Re: Affected Property Assessment Report, Former Operating Plant, Frisco Recycling Center,
Frisco, Collin County, Texas (Agreed Order Docket No. 2011-1712-IHW-E);
City of Frisco comments

This submittal is the City of Frisco's (the City's) comments on the Affected Property Assessment Report (APAR) submitted by Exide Technologies (Exide) for the former Exide battery recycling facility in Frisco, Texas. This area is also known as the Bowtie Parcel in the context of the Exide – City of Frisco Settlement Agreement that required closure of the Exide facility. The adjacent J Parcel is being purchased by the City for future development following remediation by Exide under a Texas Commission on Environmental Quality (TCEQ) Voluntary Cleanup Program (VCP) application.

COMMENTS ON APPENDIX 7 OF AFFECTED PROPERTY ASSESSMENT REPORT,
FORMER OPERATING PLANT, FRISCO RECYCLING CENTER, FRISCO, COLLIN COUNTY,
TEXAS (AGREED ORDER DOCKET NO. 2011-1712-IHW-E), PASTOR, BEHLING &
WHEELER LLC, DATED 7/10/2013

Cross Section Location Map

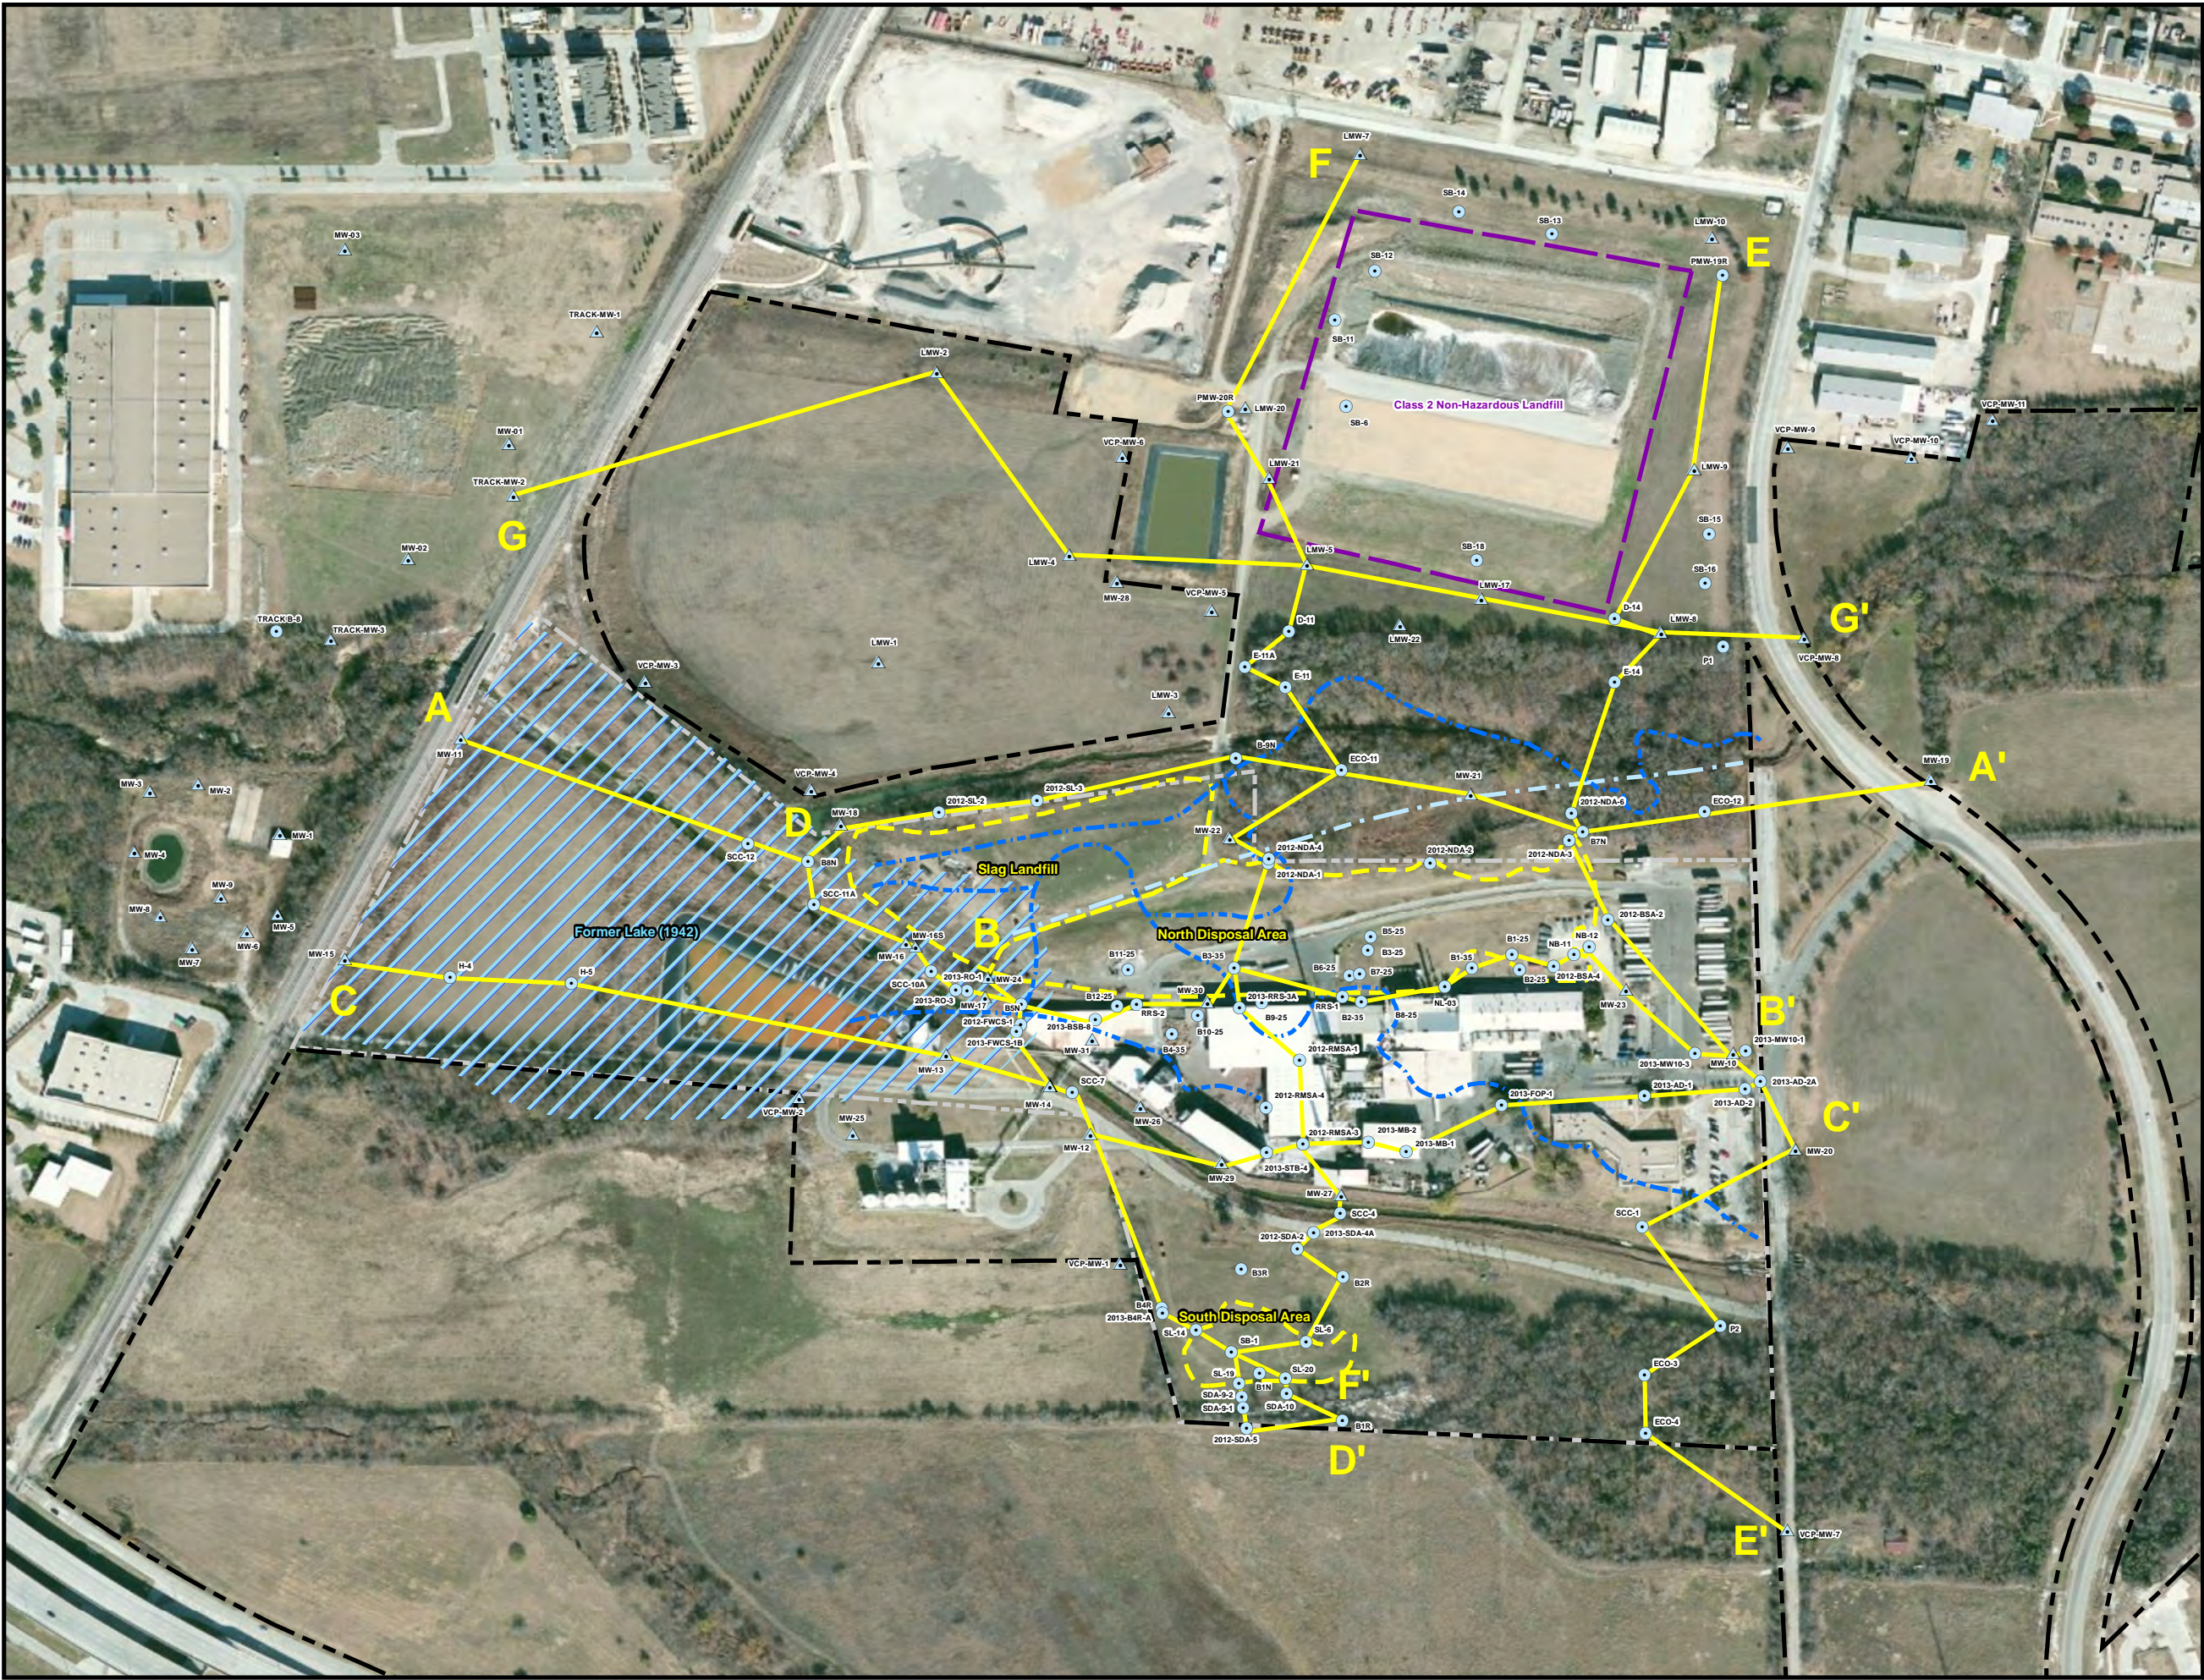
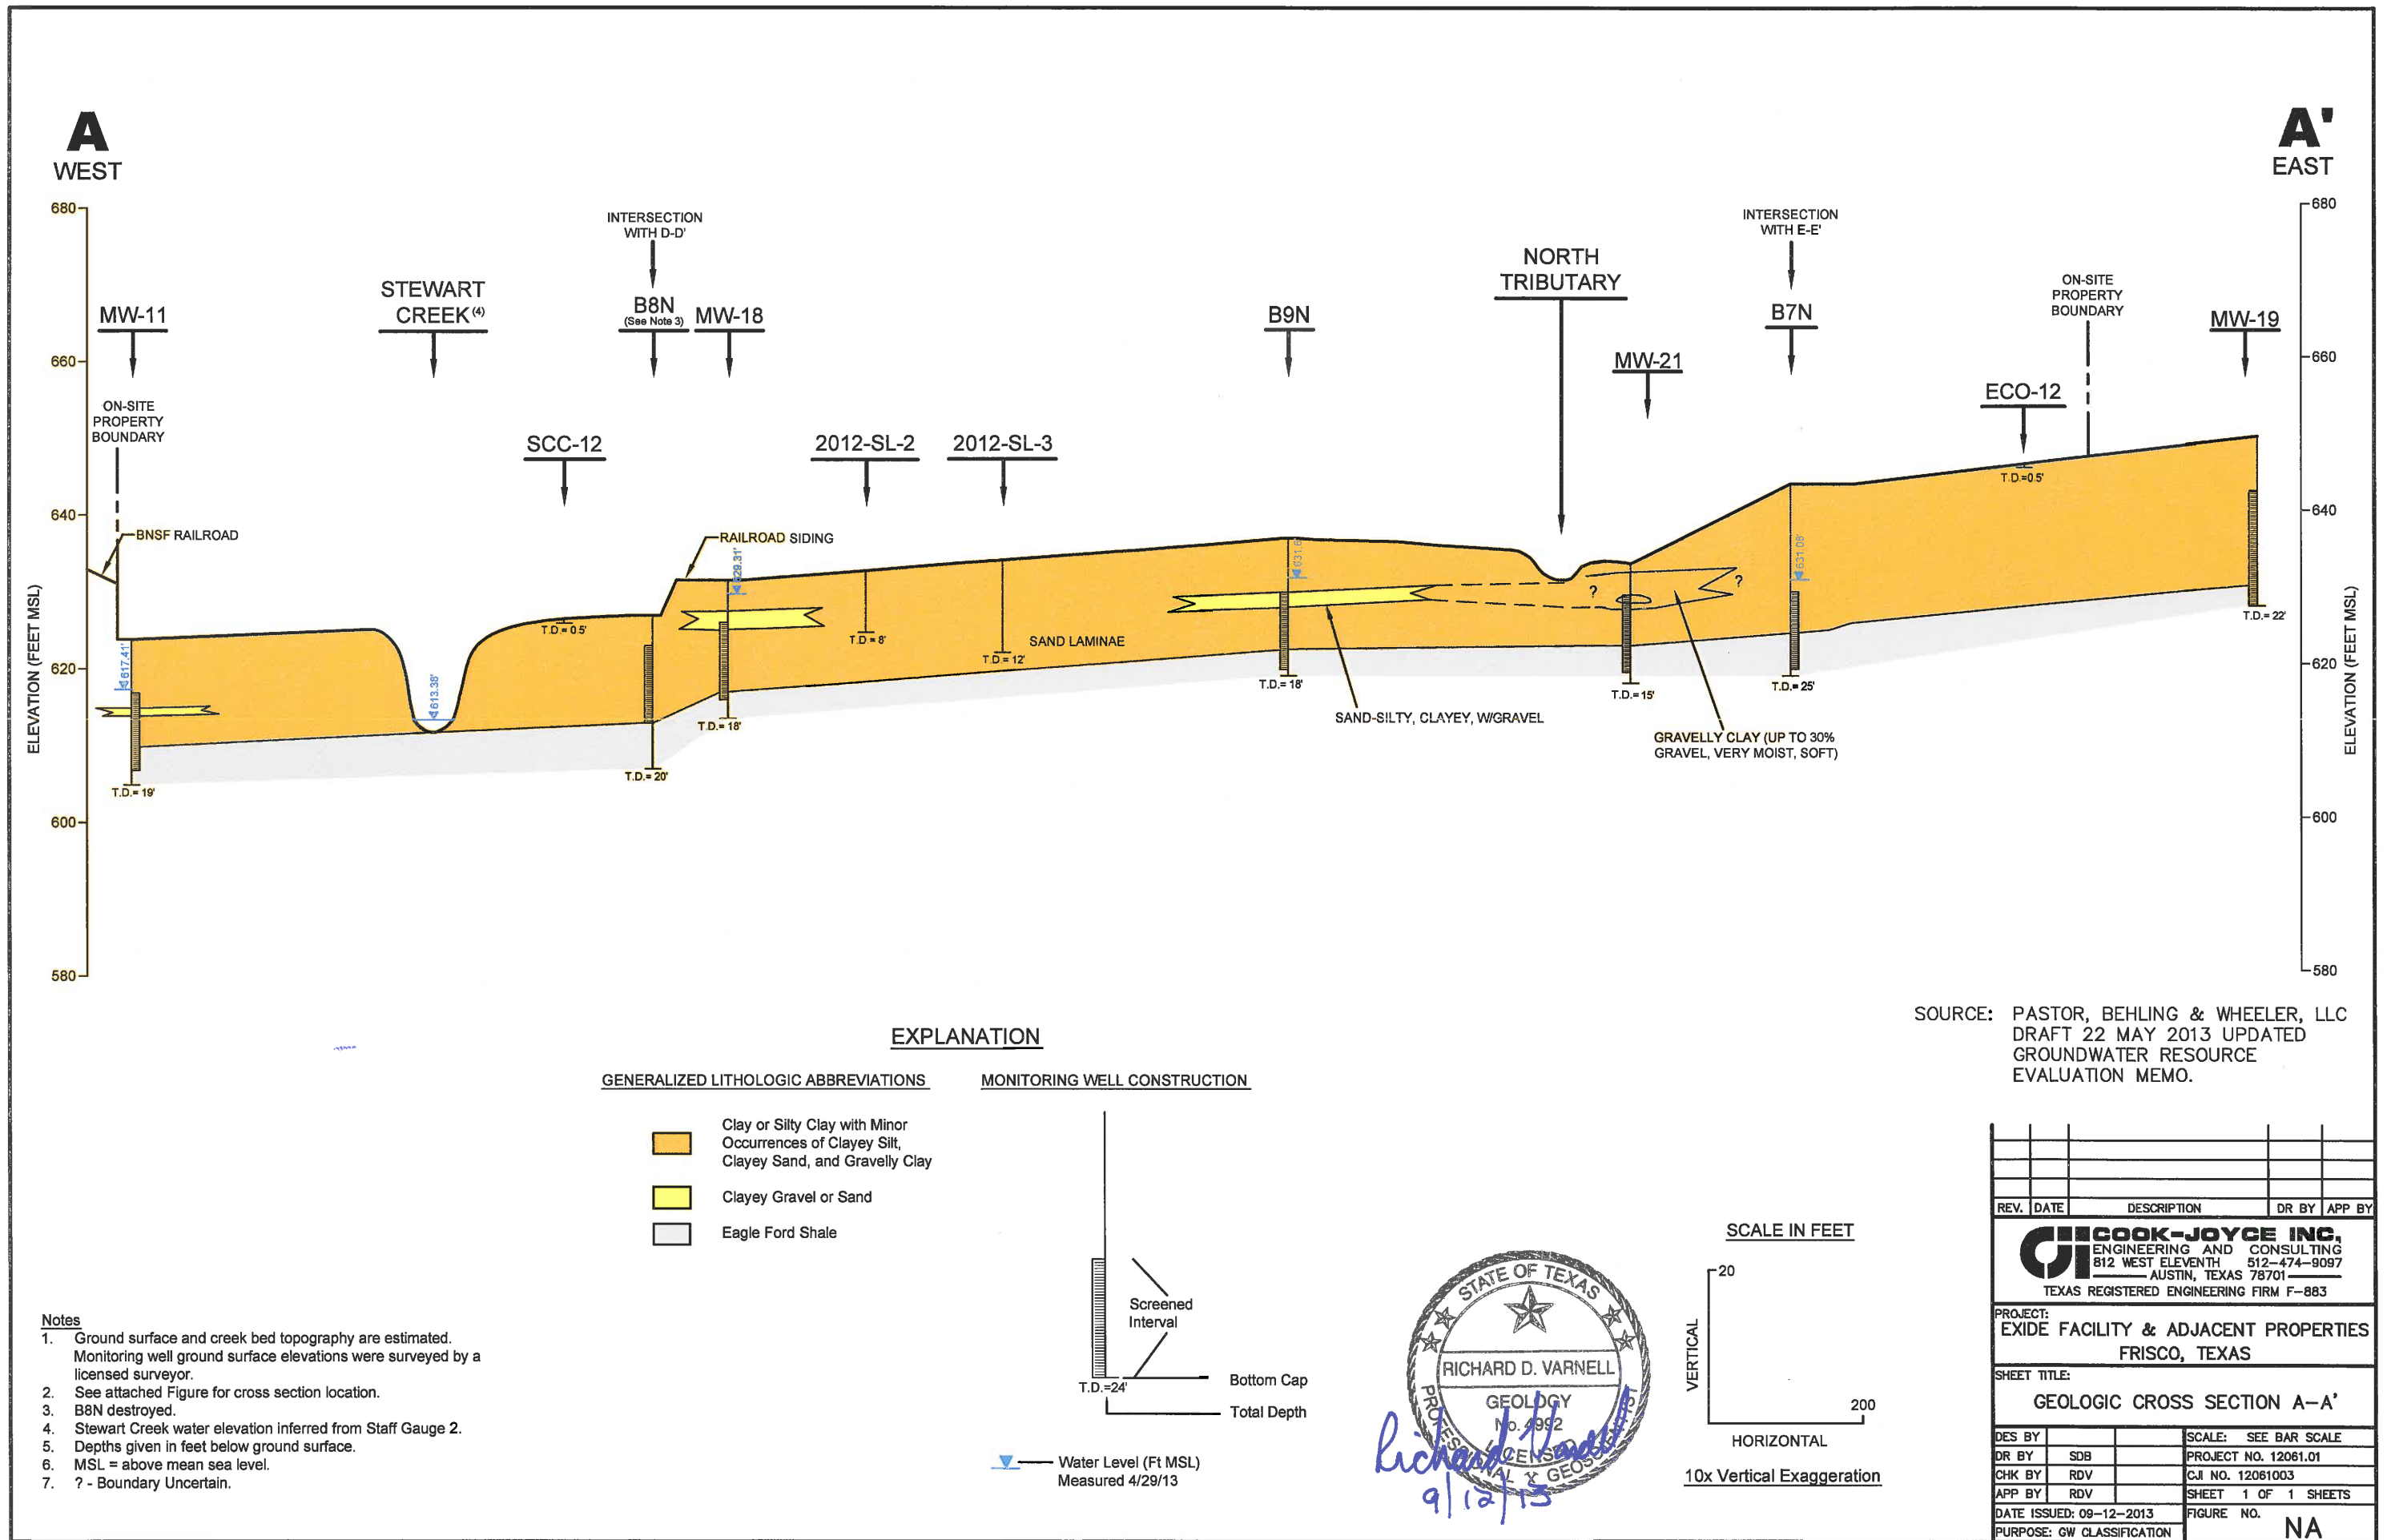
A key part of the Exide groundwater classification argument is that the hydrogeology of the groundwater bearing unit (GWBU) consists of disconnected areas of highly permeable sand and gravel. See Section 6.2.2 of Appendix 7 Updated Groundwater Resource Classification Evaluation. The City notes that Exide provides very convoluted cross sections in the APAR to support this argument. These cross sections defy common sense and normally accepted professional practice. Prior to submission of the APAR, the City provided Exide with accurate cross sections which demonstrate the continuous nature of the subsurface hydrogeology. Exide chose not to include these accurate cross sections in the APAR since they undercut the basic technical assumption for Exide's convoluted regulatory argument for a Class 3 groundwater designation. Those cross sections are included in Attachment C.

The cross sections that were included with the Groundwater Memo (Sections A-A’ through F-F’) have been revised to illustrate the interpretation of the City’s consultants that connectivity exists between transmissive strata at the site and are attached to this document.
